ORIGINATION FORM

Proposed Revisions to a Standard Plans Index

Index Number: 455-154
Sheet Number (s): 1
Index Title: 54" Precast/Post-Tensioned CFRP & SS
Concrete Cylinder Pile

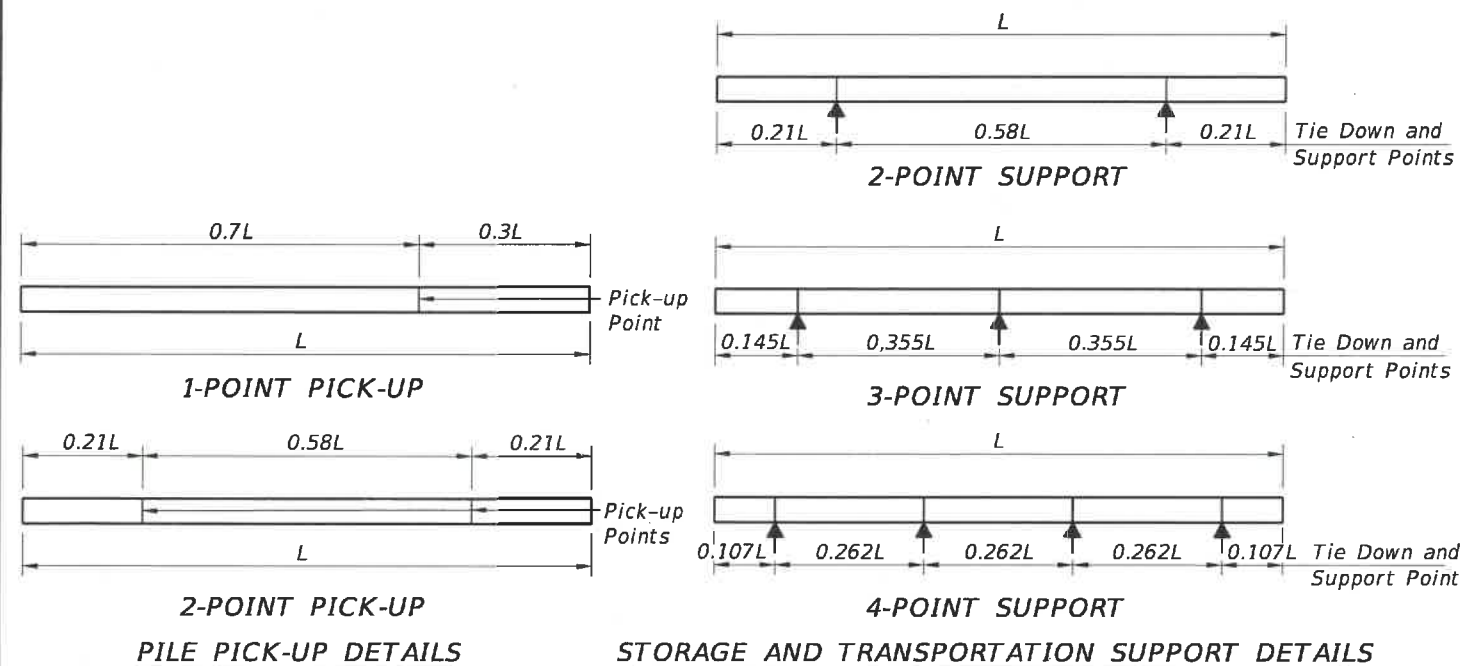
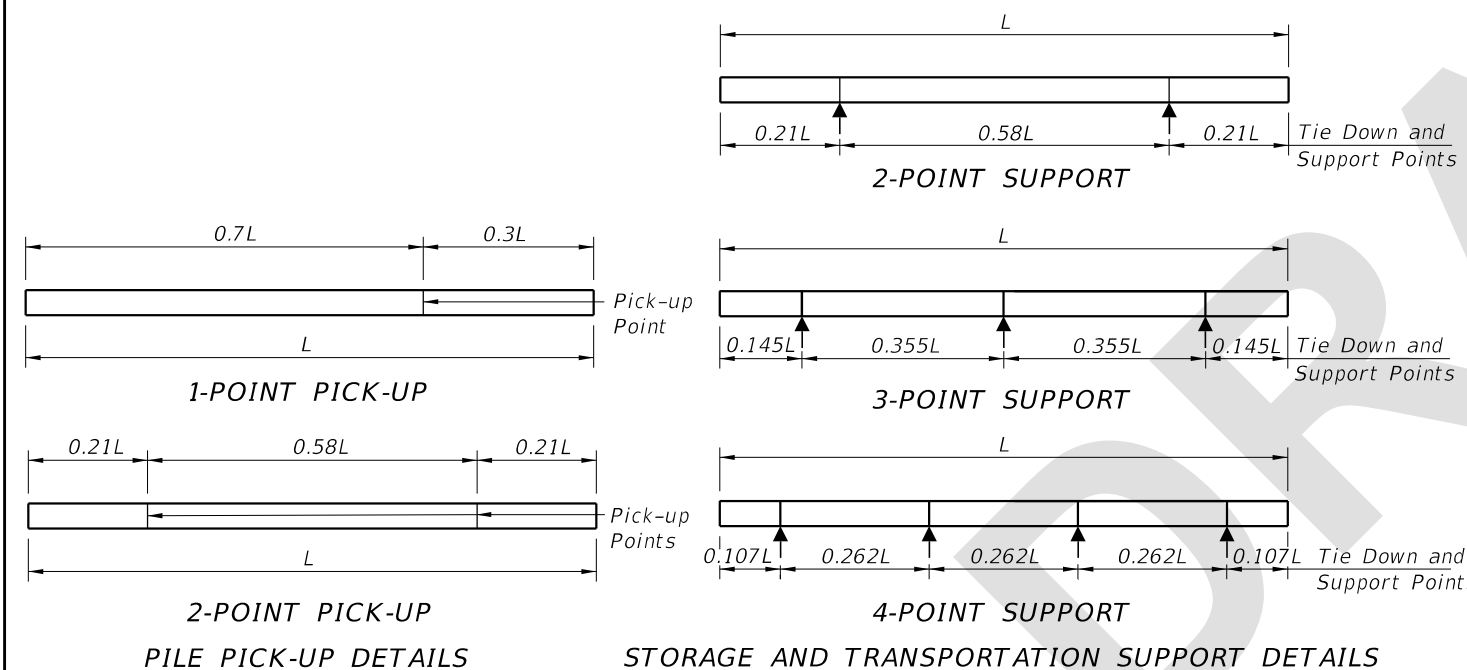
Changed Class V (Special) concrete to Class V.

1. Work this Index with the Pile Data Table in the Structures Plans.
2. Concrete:
 - A. Piles: Class V (Special)
 - B. Splice: Class IV
 - C. See "GENERAL NOTES" in Structures Plans for locations where the use of Highly Reactive Pozzolans is required for options using stainless steel strand and reinforcing.

1. Work this Index with the Pile Data Table in the Structures Plans.
2. Concrete:
 - A. Piles: Class V
 - B. Splice: Class IV
 - C. See "GENERAL NOTES" in Structures Plans for locations where the use of Highly Reactive Pozzolans is required for options using stainless steel strand and reinforcing.
